Smithy Place Lane, Honley
HD9 6PR

Stage 1 Road Safety Audit

Report title:	Stage 1 Road Safety Audit
Date:	17th September 2026
Document reference and revision:	169955-001-02
Prepared by:	Sanderson Associates
On behalf of:	Kirklees
	Council (Overseeing Organisation)

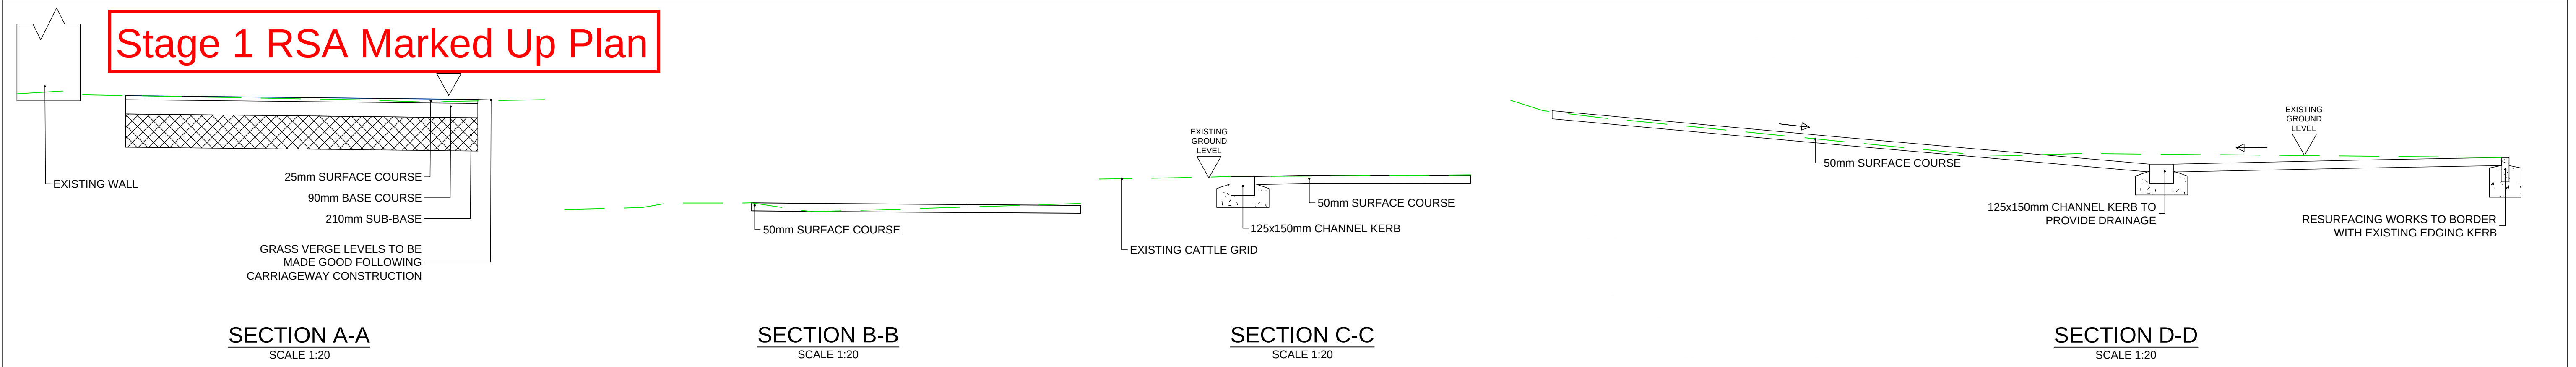
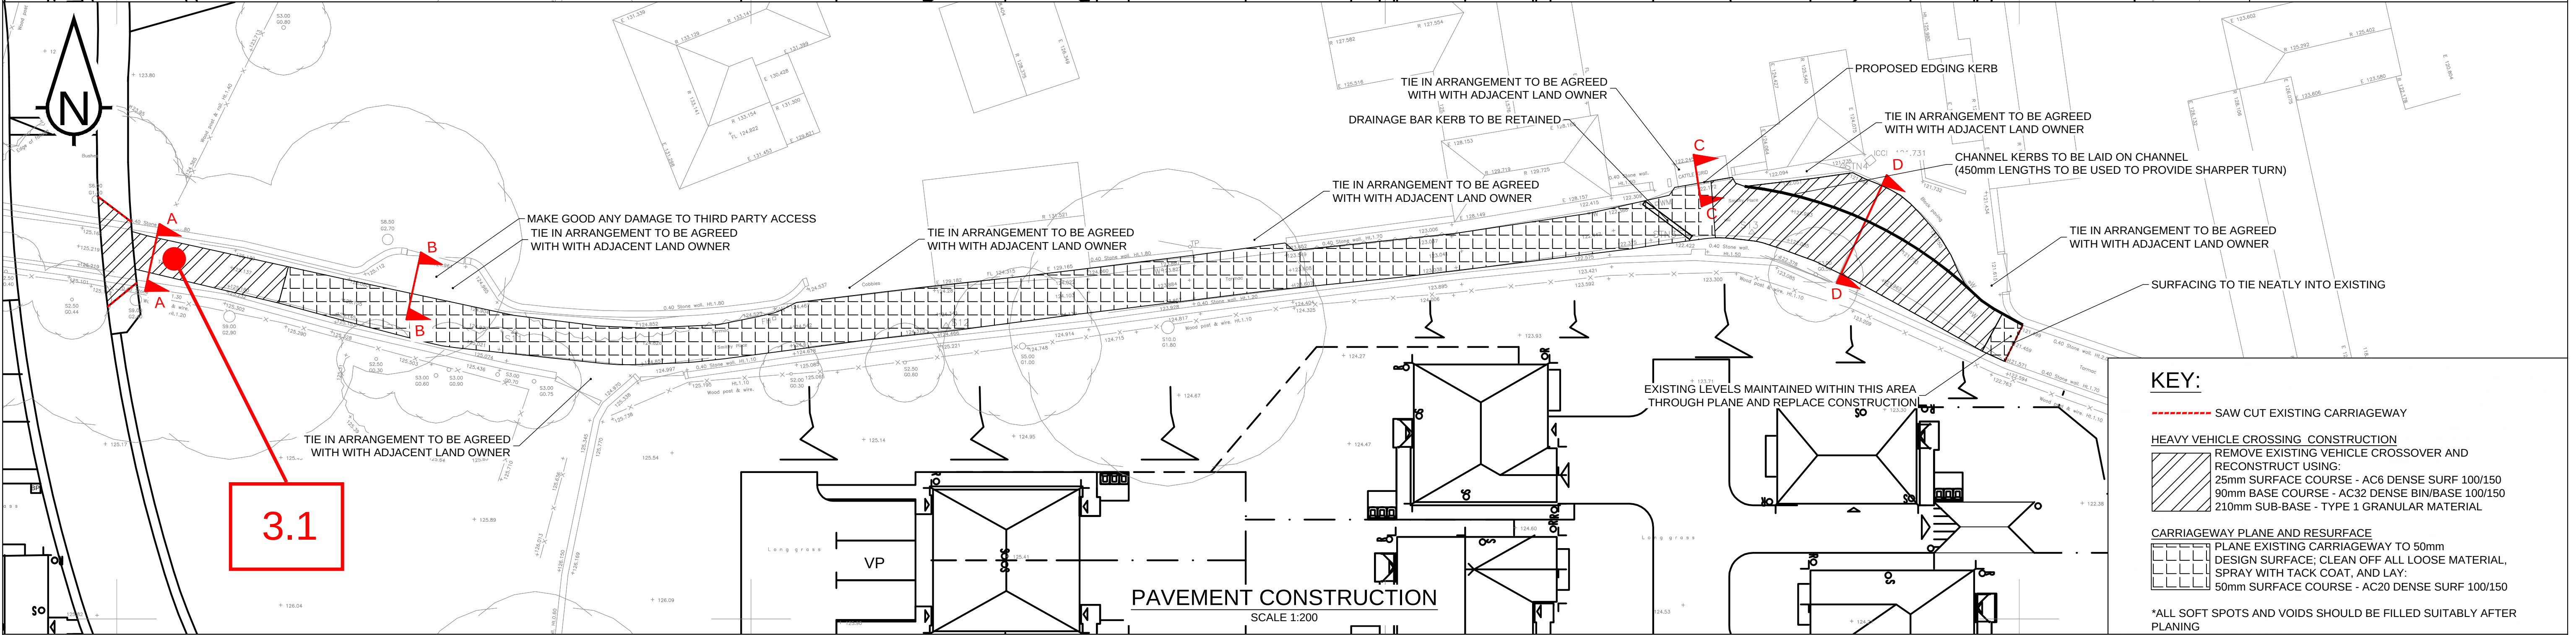
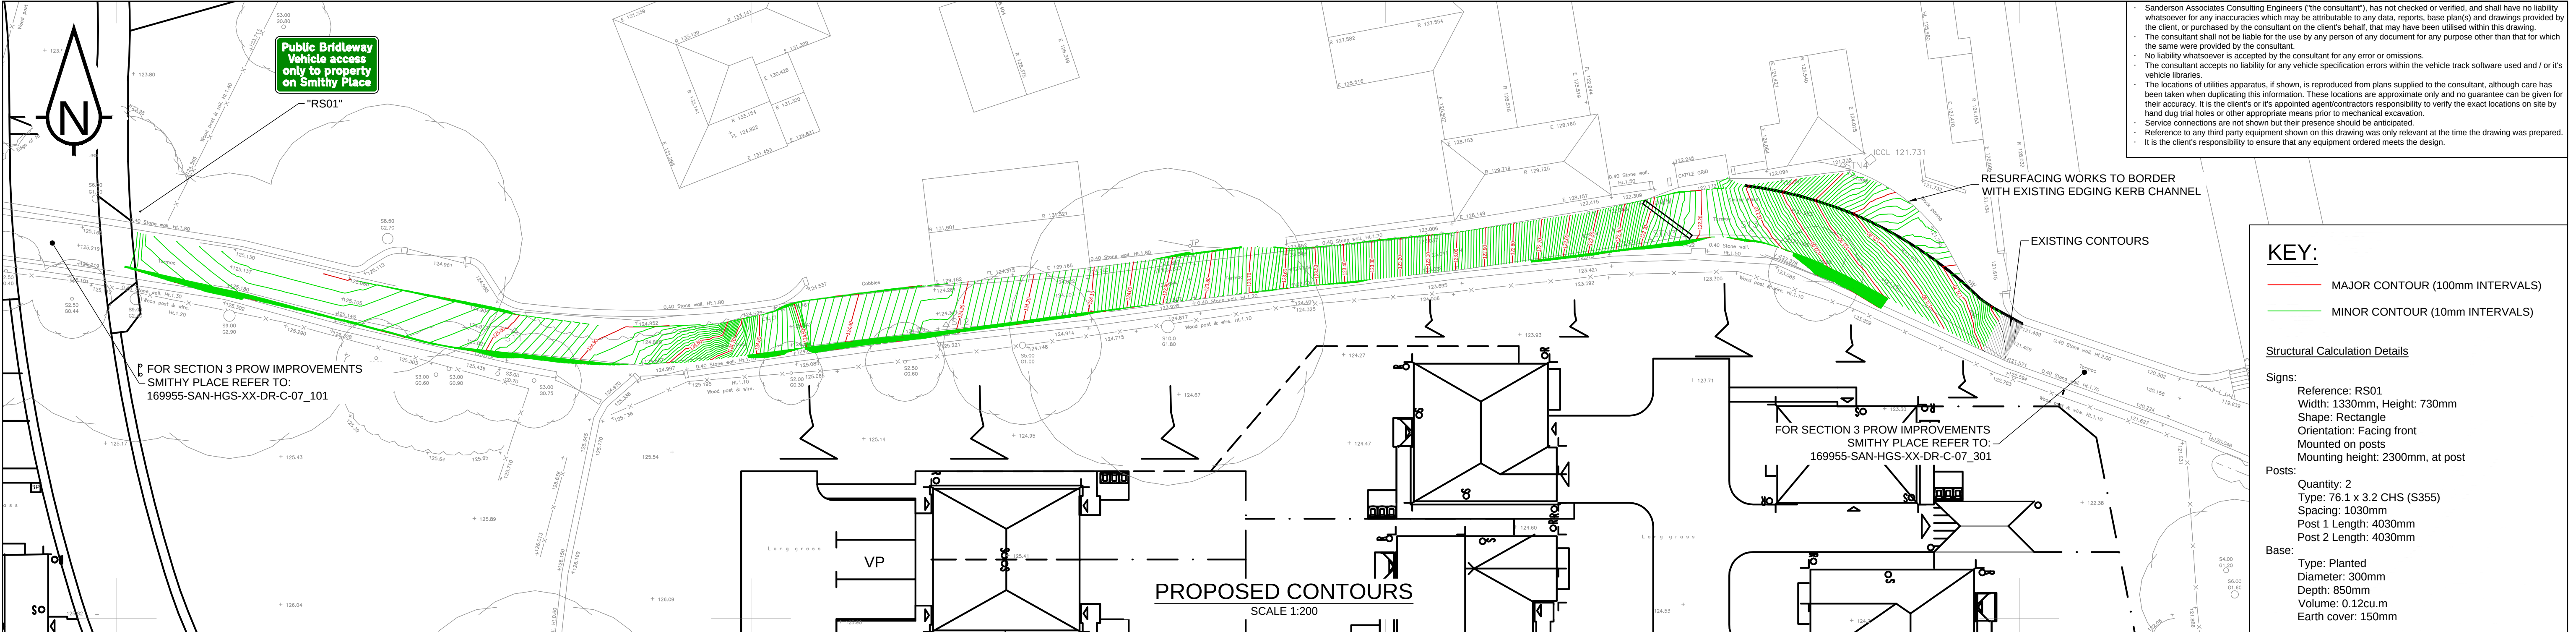
Problem 3.1:

Location: Smithy Place near Oak Way.

Summary: Potential vehicular access to the residential development

Detail: Vehicular access to the properties on Smithy Place is currently, and should remain, solely from the existing junction with Smithy Place Lane. However, the improvement works widen and improve the surface of the PROW, particularly along the short section beyond the last residential property, up to the crossing point on Oak Way, and the design includes a sign at the Oak Way crossing reading "public bridleway vehicle access only to property on Smithy Place". This wording, combined with the improved surface and width, does not preclude use of this section by existing residents seeking to egress into the Miller Homes development, nor does it prevent non-resident drivers from within the development using it to access Smithy Place or as a through route to Smithy Place Lane. Retaining any vehicular function on this short section introduces unnecessary conflict between vehicles and pedestrians, cyclists and equestrians, on a link that could otherwise be designed to promote NMU use exclusively. There doesn't appear to be an operational need for this section to accommodate vehicles in either direction, given that suitable vehicular access already exists via Smithy Place Lane.

Recommendation: It is recommended that the short section of PROW between the last residential property on Smithy Place and the Oak Way crossing is designed and signed to exclude vehicular access in both directions, including access/egress by existing Smithy Place residents, with a physical measure - such as a bollard, gate, or other restriction appropriate to NMU use - provided at this point, and that the proposed sign wording at the Oak Way crossing is amended to remove any reference to vehicle access, so that the existing junction with Smithy Place Lane remains the sole point of vehicular access to the properties on Smithy Place.
